## State Water Resources Control Board

### UST CASE CLOSURE SUMMARY

USTCF Claim No.: 12335	Global ID: T0610900033
Site Name: Twain Harte Chevron	Site Address: 22920 Twain Harte Drive Twain Harte, Tuolumne County (Site)
Petitioner: Carol Matts	Address: CALTRANS District 3, P.O. Box 911, Marysville, CA 95901
USTCF Expenditures to Date: \$897,258	Number of Years Case Open: 23

Groundwater Trends:

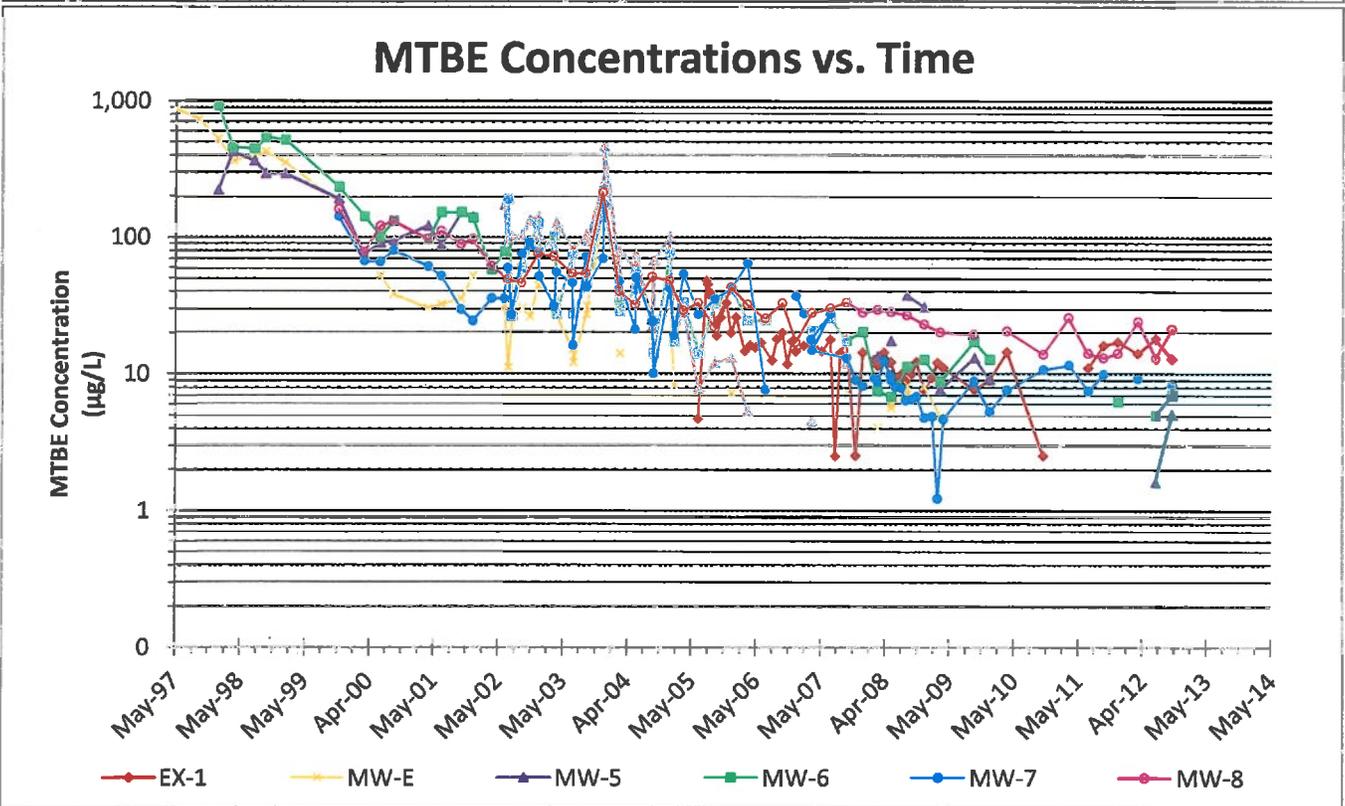
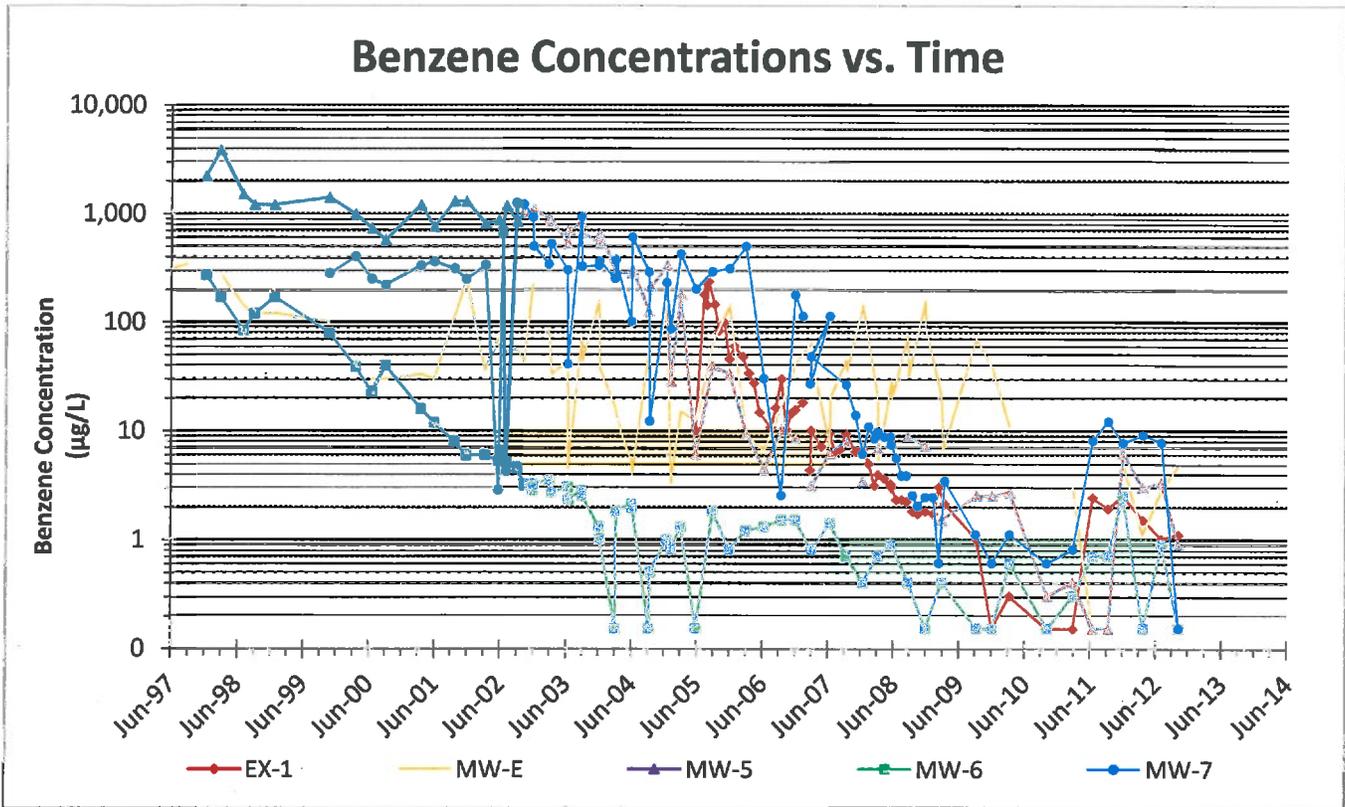
15. The Policy is based on the understanding the contaminant plume that exceeds water quality objectives must be stable or decreasing in areal extent. As concentrations in the downgradient wells are increasing, this case does not comply with this requirement.

RESPONSE: The concentrations in the well on the leading edge of the plume (MW-8) are decreasing demonstrating that the plume is stable in areal extent.

**F**  
 POTENTIOMETRIC SURFACE MAP WITH HYDROCARBON  
 CONCENTRATIONS IN GROUNDWATER, 4th QUARTER 2012  
 FORMER TWAIN HARTE CHEVRON  
 TWAIN HARTE, TUOLUMNE COUNTY, CALIFORNIA

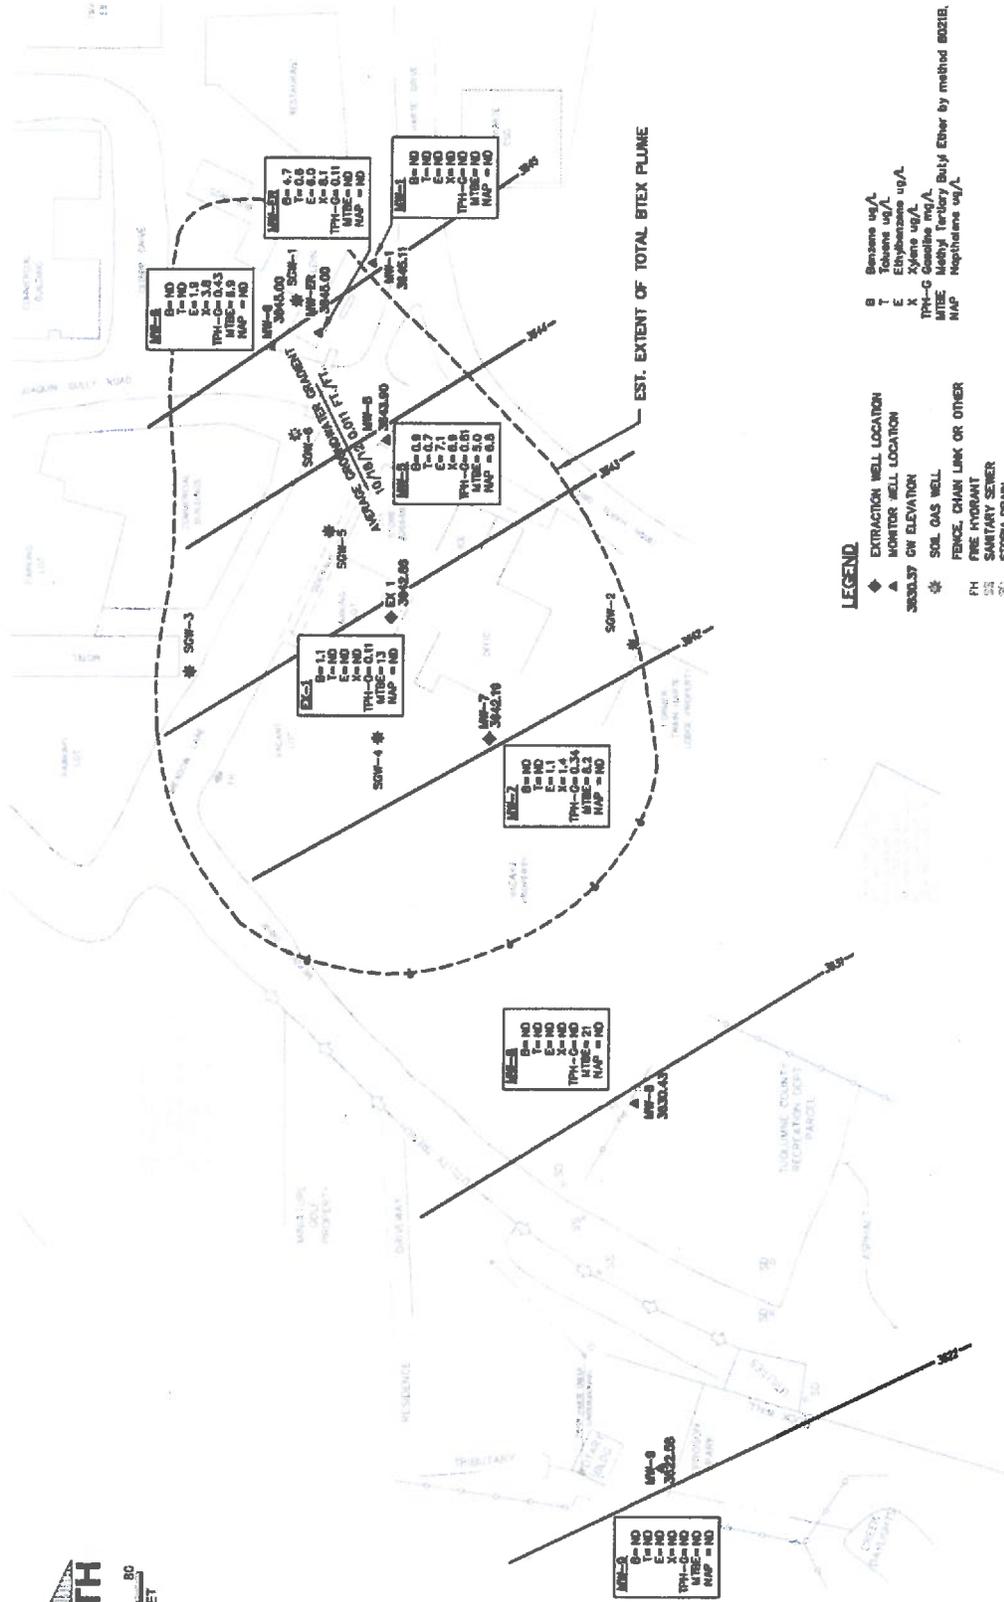
3. Delineation of groundwater impacts have not been adequately characterized in the area of high petroleum hydrocarbon concentrations noted in soil gas samples SGW-2.

4. Petroleum concentrations in off-Site wells MW-7 and EX-1 have been increasing since the groundwater extraction system was shut-off in March 2009. The distance to MW-7 indicates that the remaining mass is not limited to the immediate vicinity of the former UST.

5. Depth to groundwater in monitoring well MW-7 has been reported at 0 feet below ground surface, indicating groundwater is potentially surfacing and then discharging to surface water.

10. The Regional Water Board has stated that they believe that soil vapor samples collected from SGW-2 are not valid because water may have been present in the soil vapor well SGW-2 during sample collection due to a very moist condition noted at the time of well installation.

RESPONSE: The 38 soil borings and eleven monitoring wells adequately define the plume. The soil gas concentrations in the vicinity of SGW-2 don't warrant further investigation because they meet the requirements of the Policy.

RESPONSE: Dissolved petroleum constituents have fluctuated due to seasonal, sampling, and analytical variations. The last eleven years of analytical data, including pre and post remedial activity, have demonstrated that constituent concentrations are decreasing. The Policy definition of a stable plume is that the plume has reached its maximum extent. Site data meets the policy definition of a stable plume.

RESPONSE: Monitoring well MW-7 is located in a low lying area and the well vault is susceptible to collection of surface runoff which may provide an appearance that the groundwater has reached the surface. Over the last 23 years there is no empirical evidence collected that suggests groundwater is surfacing.

RESPONSE: A helium shroud was placed over the sampling train during sample collection and the leak detection compound that filled the shroud, was not detected in the soil vapor sample thereby eliminating the possibility of collection of ambient air via short circuiting. No water was detected in the sample collected from SGW-2. While SGW-2 and MW-7 are laterally close the elevation at SGW-2 is approximately 10 feet higher than the elevation at MW-7. Depths to groundwater at wells with similar elevations to SGW-2 have been approximately 10 to 33 feet below ground surface therefore it is unlikely that 5 foot deep SGW-2 contained water during sample collection.
